## **Statement of Environmental Effects to support a Modification (S4.55)**

Modification to an approved development for  
Division 8.2 Review of Council's Refusal for  
Demolition of Existing Site Structures and  
Construction of an Attached Dual Occupancy  
with Basement Level and Torrens Title  
Subdivision.

17 Hillview Avenue, Bankstown

## Modified Statement of Environmental Effects

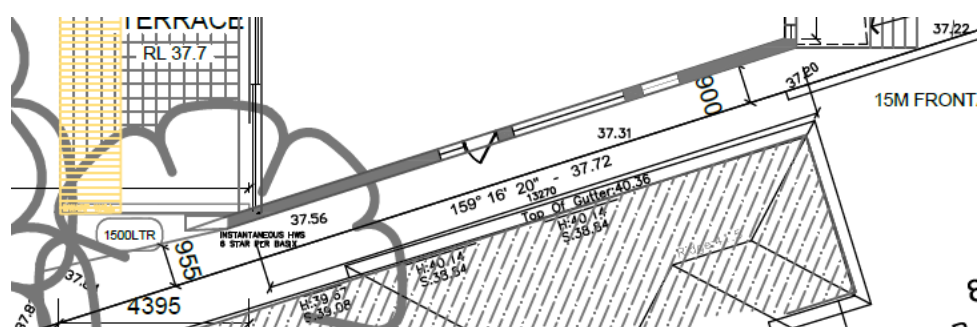
ITEM 1: Side setback of external wall along western boundary reduced from approved 900mm to 850-860mm setback as per as-built survey provided by Sydney Registered Surveyors.

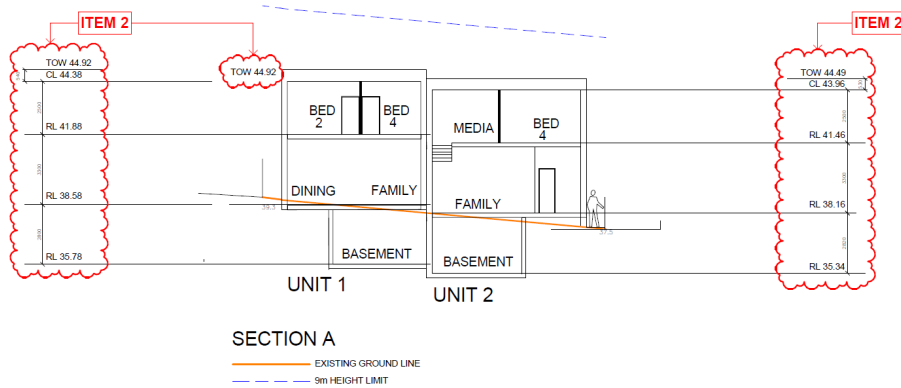
allotment, the two dwellings forming the dual occupancy may be subdivided provided the minimum lot size is 450m <sup>2</sup> per dwelling.	
<b>Storey limit (not including basements)</b>	
<b>4.4</b> The storey limit for dual occupancies is 2 storeys. In addition, dual occupancies in the foreshore protection area (refer to map in Appendix 1) must ensure the wall height does not exceed 7 metres and the building height does not exceed 9 metres.	No change is proposed by the modification
<b>4.5</b> The siting of dual occupancies, and landscaping works must be compatible with the existing slope and contours of the allotment and any adjoining property.  Council does not allow any development that involves elevated platforms on columns; or excessive or unnecessary terracing, rock excavation, retaining walls or reclamation.	No change is proposed by the modification
<b>4.6</b> Any reconstituted ground level on the allotment must not exceed a height of 600mm above the ground level (existing) of an adjoining property except where: (a) the dual occupancy is required to be raised to achieve a suitable freeboard in accordance with Part B12 of this DCP; or (b) the fill is contained within the ground floor perimeter of the dual occupancy to a height no greater than 1 metre above the ground level (existing) of the allotment.	ITEM 2 Building levels amended as per as-built survey provided by Sydney Registered Surveyors

<p>Approved development</p>  <p>SECTION A</p> <p>— EXISTING GROUND LINE</p> <p>The diagram shows a cross-section of two adjacent units, Unit 1 and Unit 2. Unit 1 has a basement, dining, family, and two bedrooms (BED 2 and BED 4). Unit 2 has a basement, family, media, and a bedroom (BED 4). The existing ground line is shown as a dashed line. Various levels are marked: TOW 44.4, CL 44.0, RL 41.5, RL 38.2, RL 35.8, TOW 44.1, CL 43.7, RL 41.2, RL 37.9, and RL 35.5. A person is shown standing on the ground level for scale.</p>	
Modification

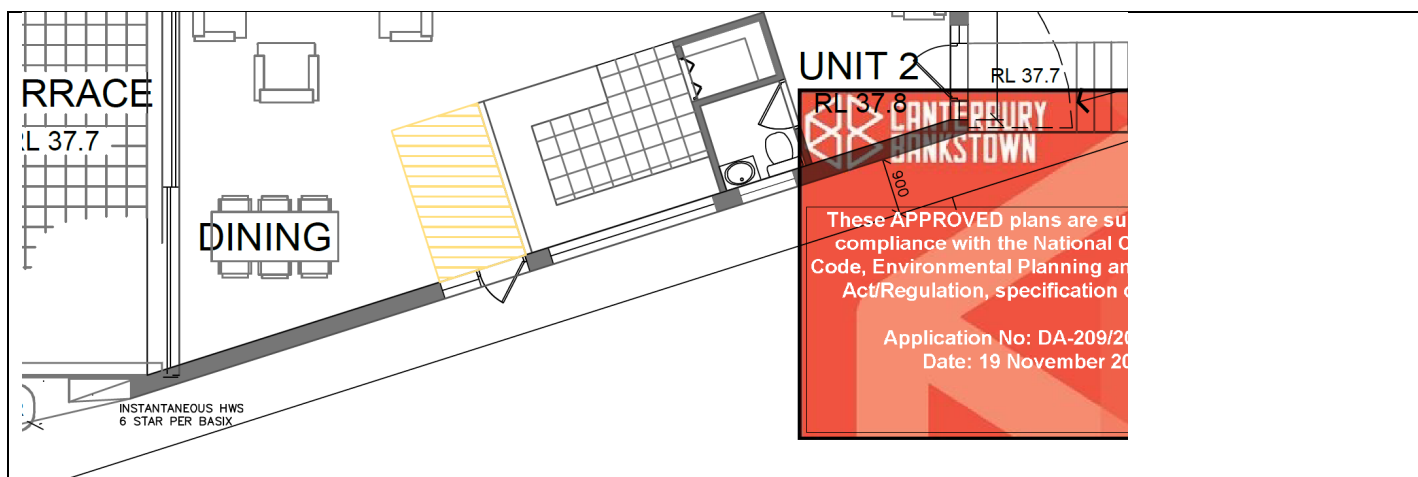
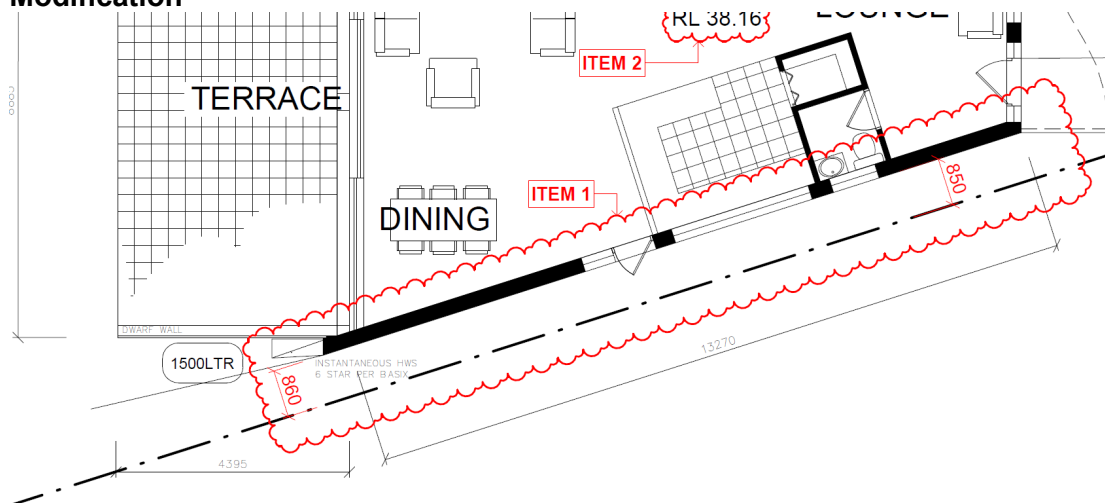
<b>Setback restrictions</b>	
<b>4.7</b> The erection of dual occupancies is prohibited within 9 metres of an existing animal boarding or training establishment.	No change is proposed by the modification
<b>Setbacks to the primary and secondary road frontages</b>	
<b>4.8</b> The minimum setback for a building wall to the primary road frontage is: (a) 5.5 metres for the first storey (i.e. the ground floor); and (b) 6.5 metres for the second storey.	No change is proposed by the modification
<b>4.9</b> The minimum setback to the secondary road frontage is: (a) 3 metres for a building wall; and (b) 5.5 metres for a garage or carport that is attached to the building wall.	No change is proposed by the modification
<b>Setbacks to the side boundary</b>	
<b>4.10</b> For the portion of the building wall that has a wall height less than or equal to 7 metres, the minimum setback to the side boundary of the allotment is 0.9 metre. Council may increase the minimum setback to reduce any impact on the amenity of an adjoining dwelling or to avoid the drip line of a tree on an adjoining property.	ITEM 1 Side setback of external wall along western boundary reduced from approved 900mm to 850-860mm setback as per as-built survey provided by Sydney Registered Surveyors  The modification does not have any impact on the amenity of the neighboring dwelling due to the floor level (1.5mFFL) and type of windows (fire solution) to the side façade (privacy). No trees are to be removed to comply with the side setback.

### Approved Development

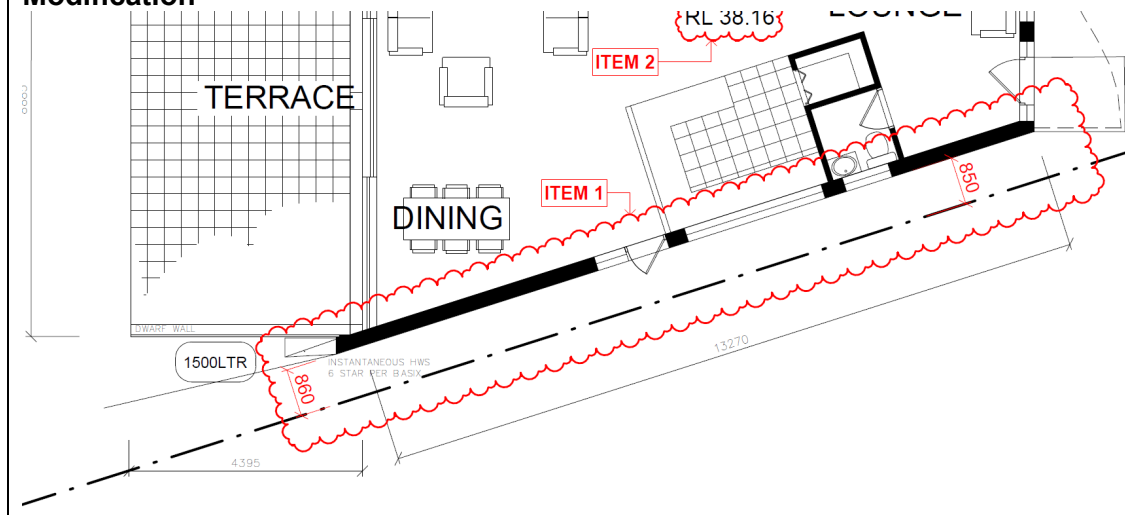
<b>4.19</b> Where development proposes a window that directly looks into the living area or bedroom window of an existing dwelling, the development must: (a) offset the windows between dwellings to minimise overlooking; or (b) provide the window with a minimum sill height of 1.5 metres above floor level; or (c) ensure the window cannot open and has obscure glazing to a minimum height of 1.5 metres above floor level; or (d) use another form of screening to the satisfaction of Council.	ITEM 1 Side setback of external wall along western boundary reduced from approved 900mm to 850-860mm setback as per as-built survey provided by Sydney Registered Surveyors  The modification does not have any impact on the amenity of the neighboring dwelling due to the floor level (1.5mFFL) and type of windows (fire solution) to the side façade (privacy).
--	--
